July 6, 2018

Amanda Lessard, Town Planner
Town of Windham
8 School Road
Windham, Maine 04062

Re: Response to Review Comments – Ruby Meadows Subdivision

18026 JOB NUMBER:
AS SHOWN SCALE:
7-6-2018 DATE:
SHEET 1 OF 5
PP-1

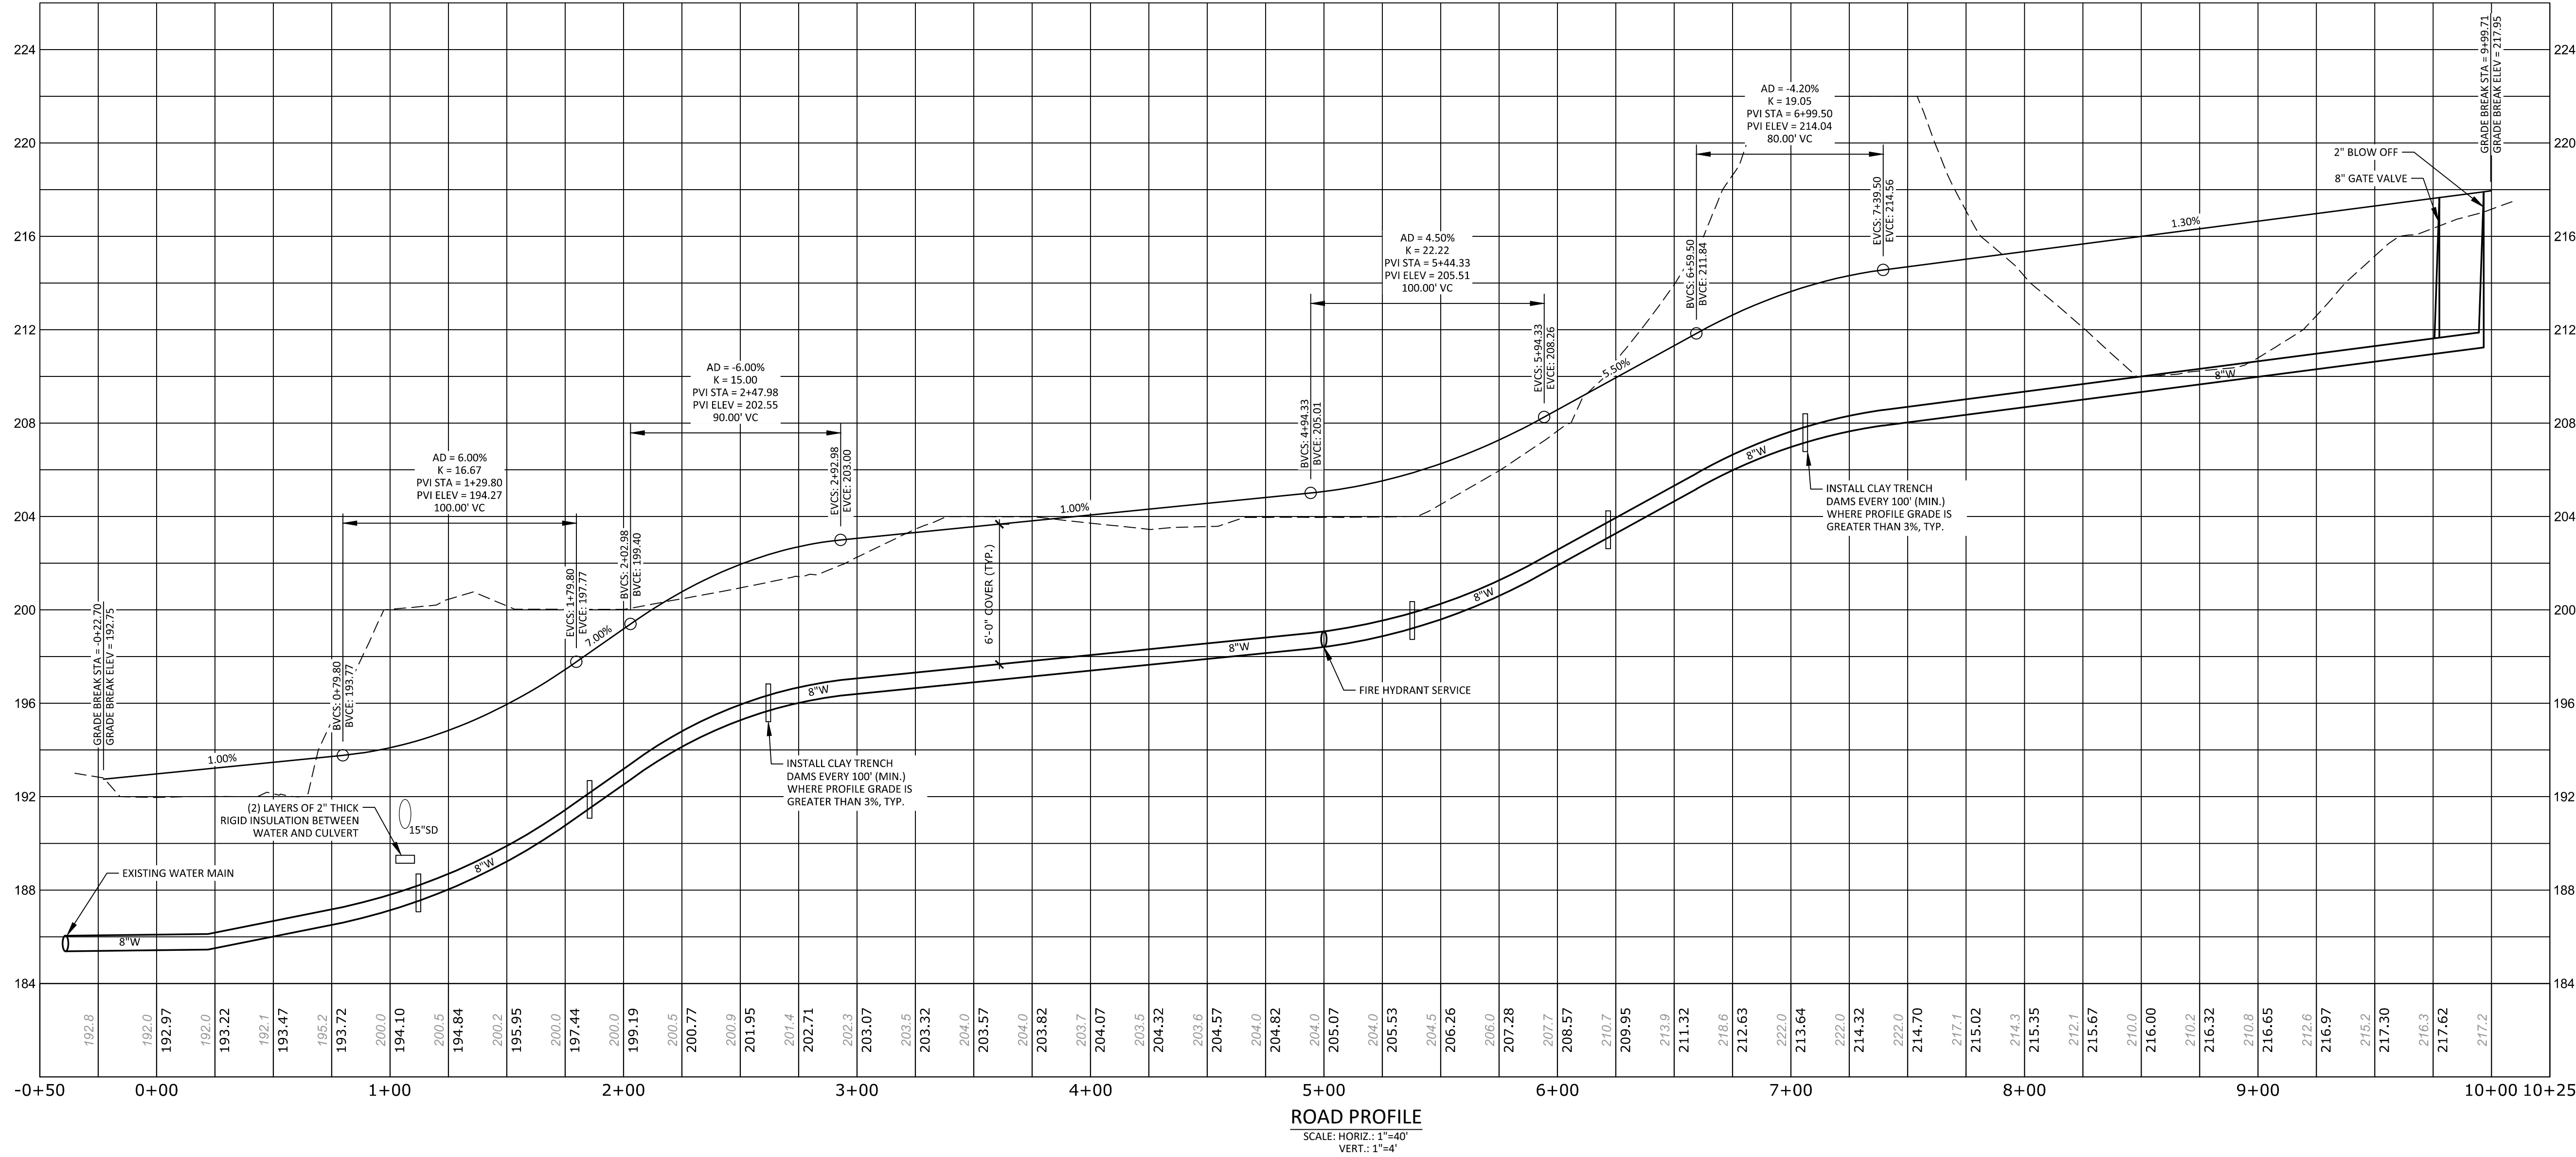
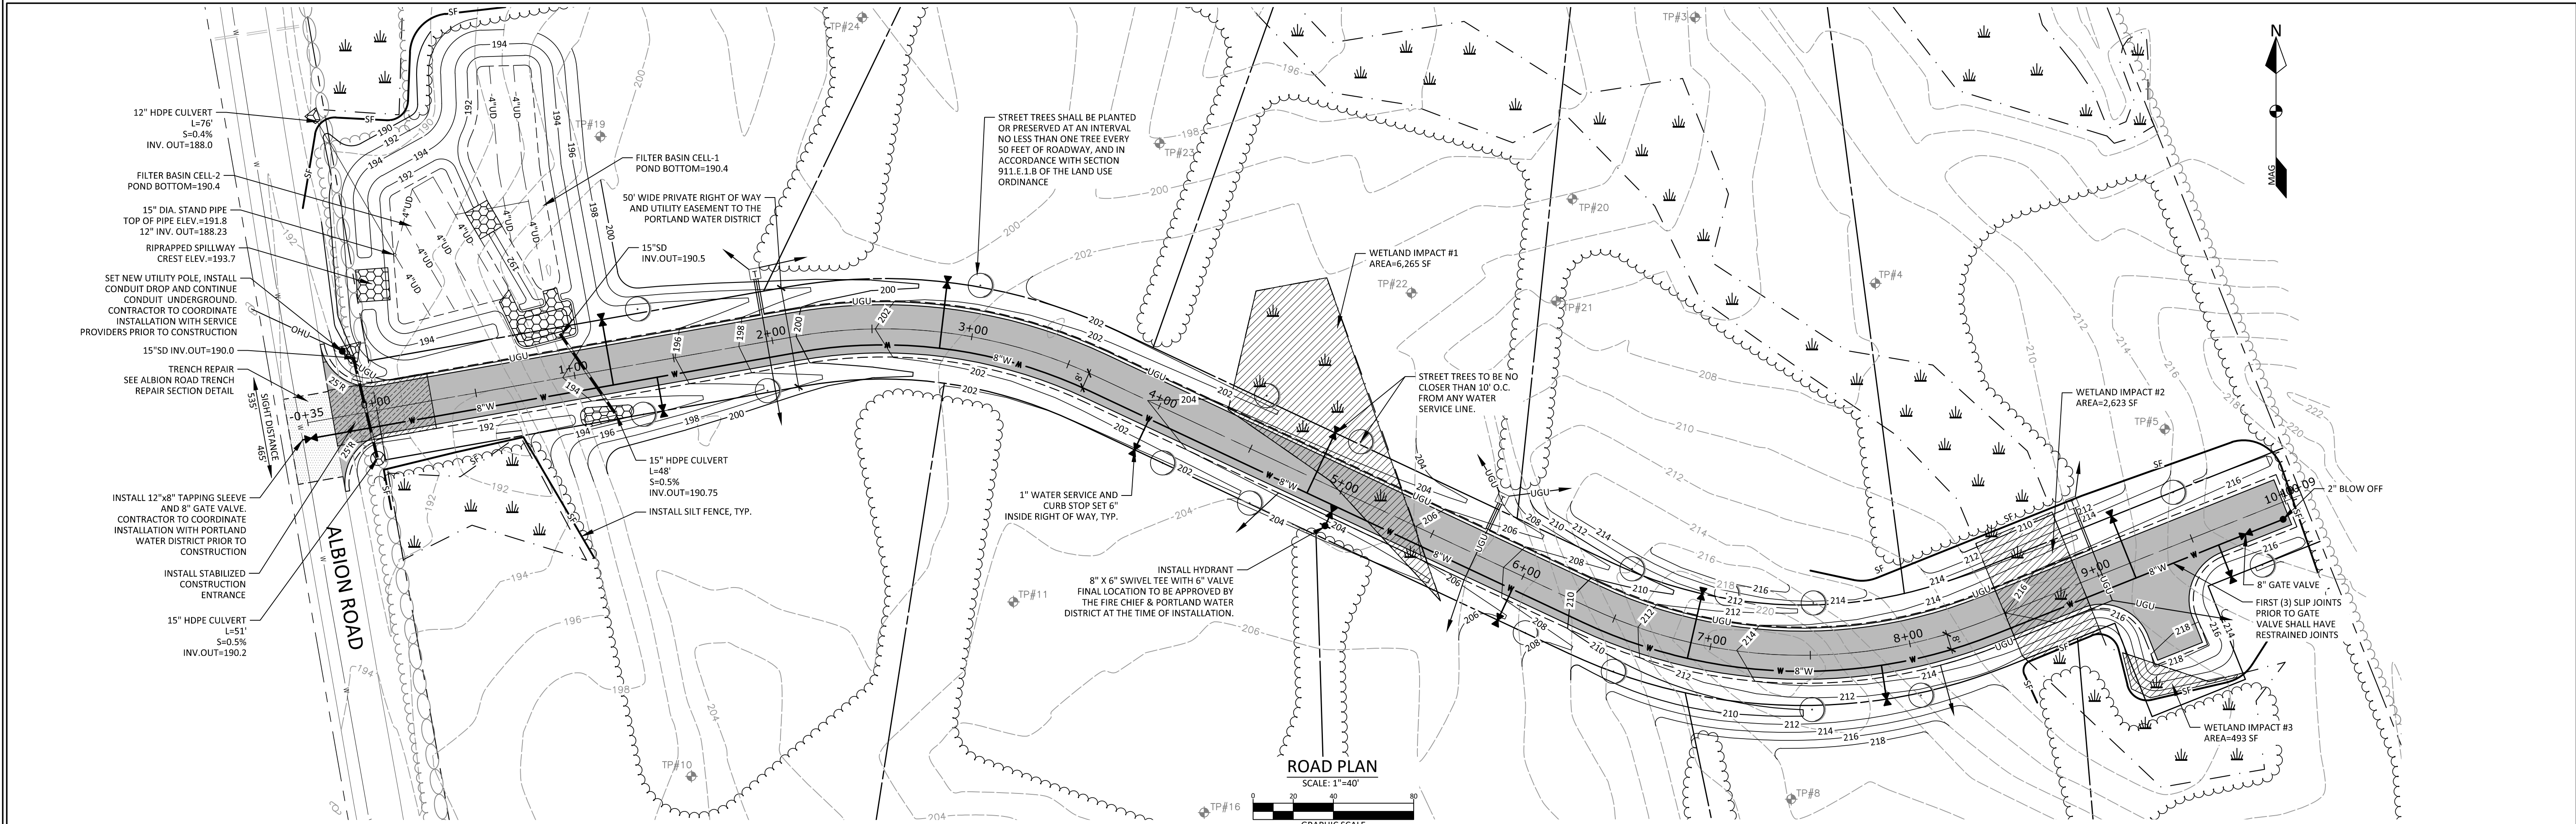
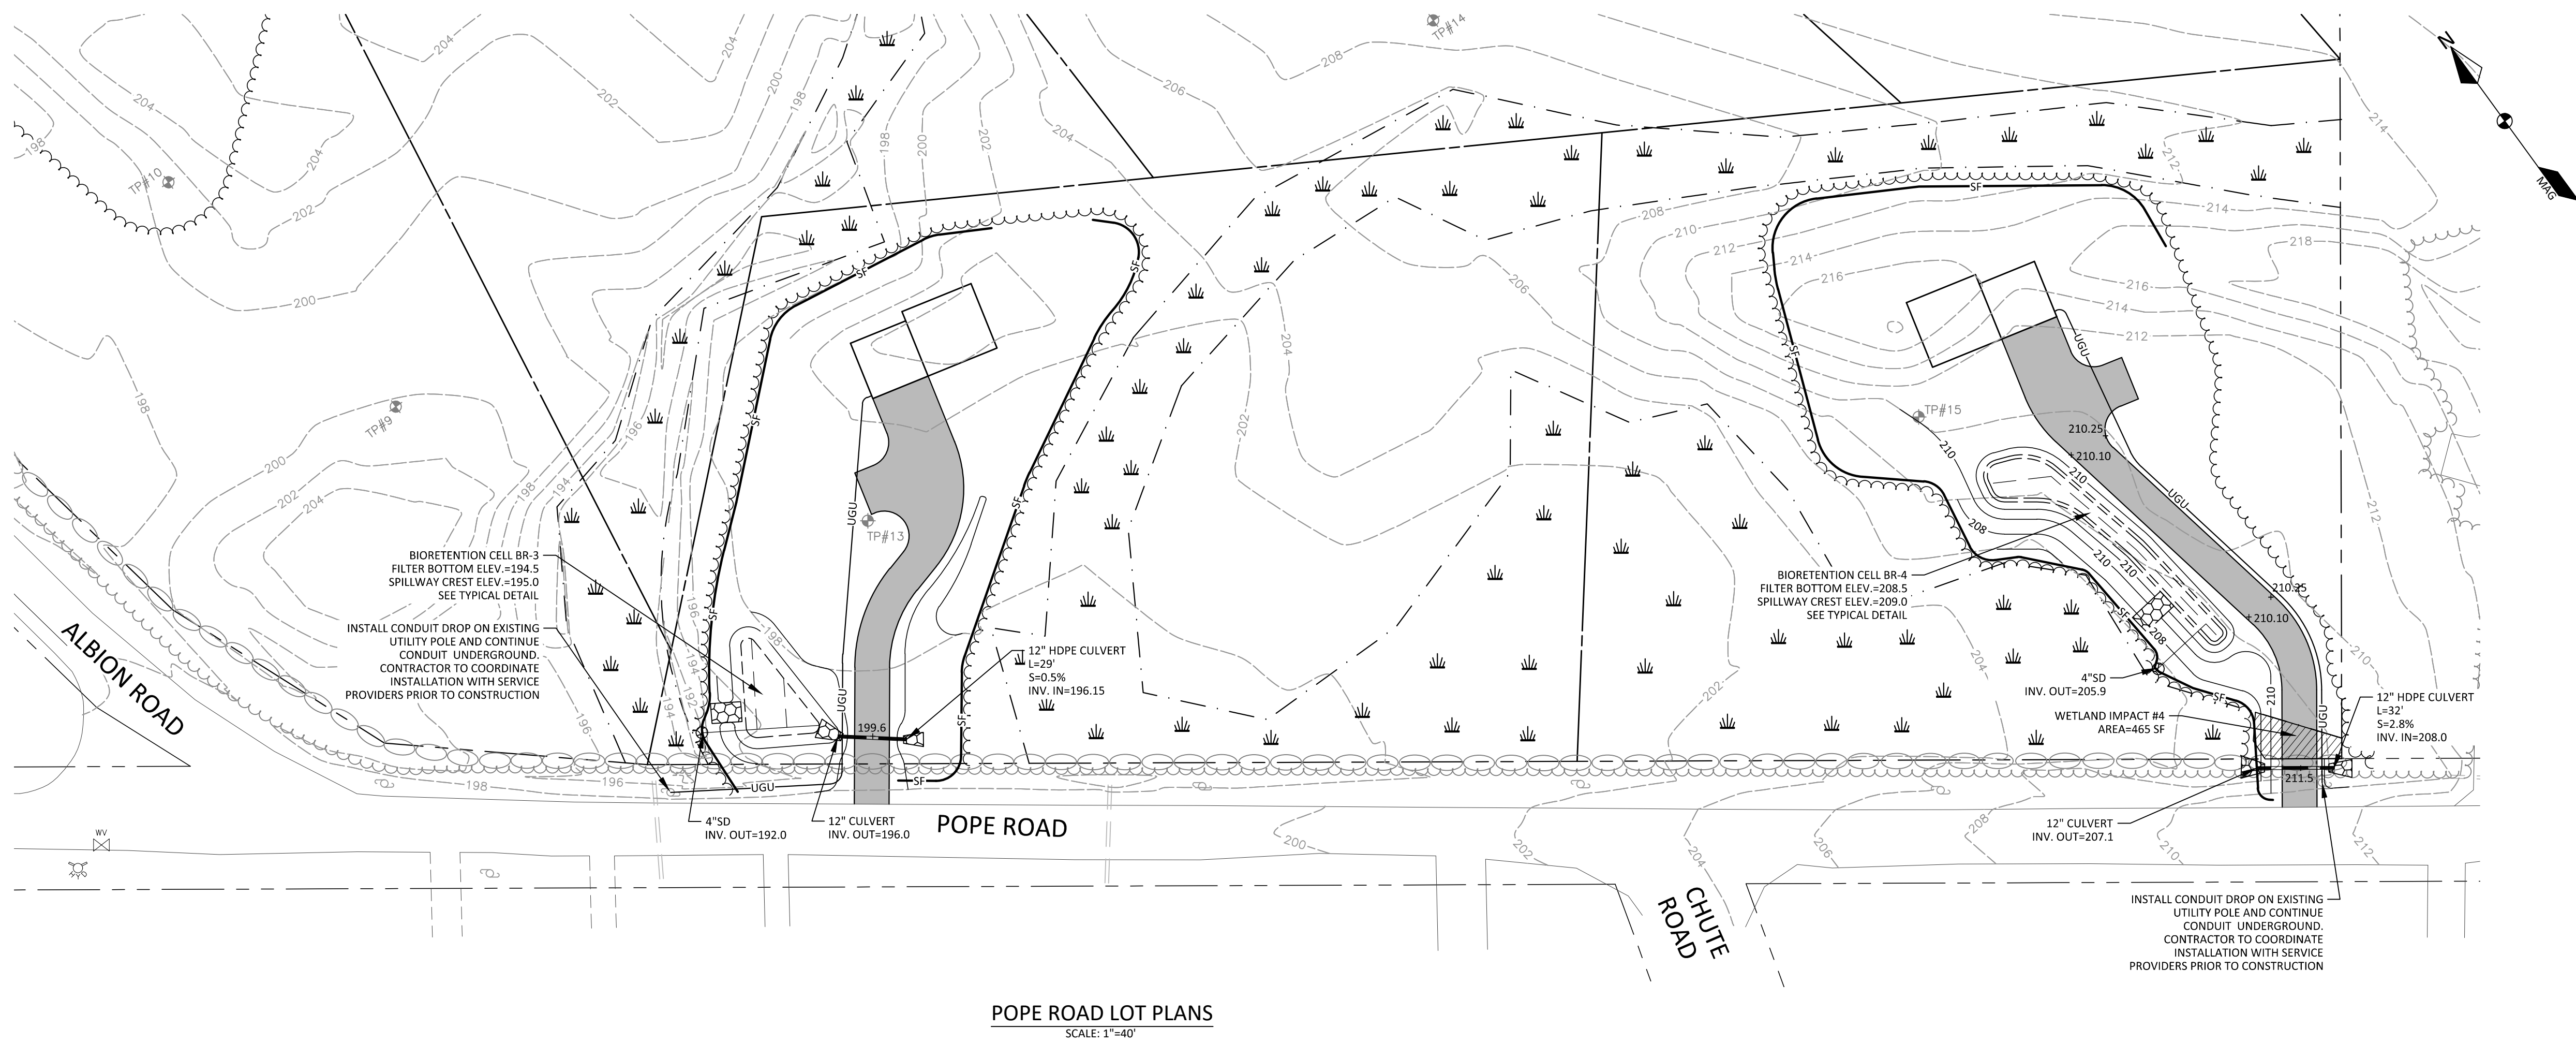
18. A revised Plan and Profile drawing is attached, which labels the sight distance at the proposed roadway intersection.
19. A roadway restoration detail was added to the plans showing the required trench repair and surface restoration for roadway trenching in Albion Road, which is under moratorium.
20. A revised Stormwater Management Report is attached, which correctly labels the pre-development flow rate at Study Point 1 as 7.18 CFS.
21. We propose that ground topography of the stormwater filter basins and rain gardens be surveyed as a condition of preliminary approval and prior to final approval.
22. A revised Lot Development Plan is attached, which shows proposed grading for the bioretention cells on lots 1, 2, 13, 14 and 15.
23. A summary table showing the proposed impervious and developed area on each lot was added to the Subdivision Plan.
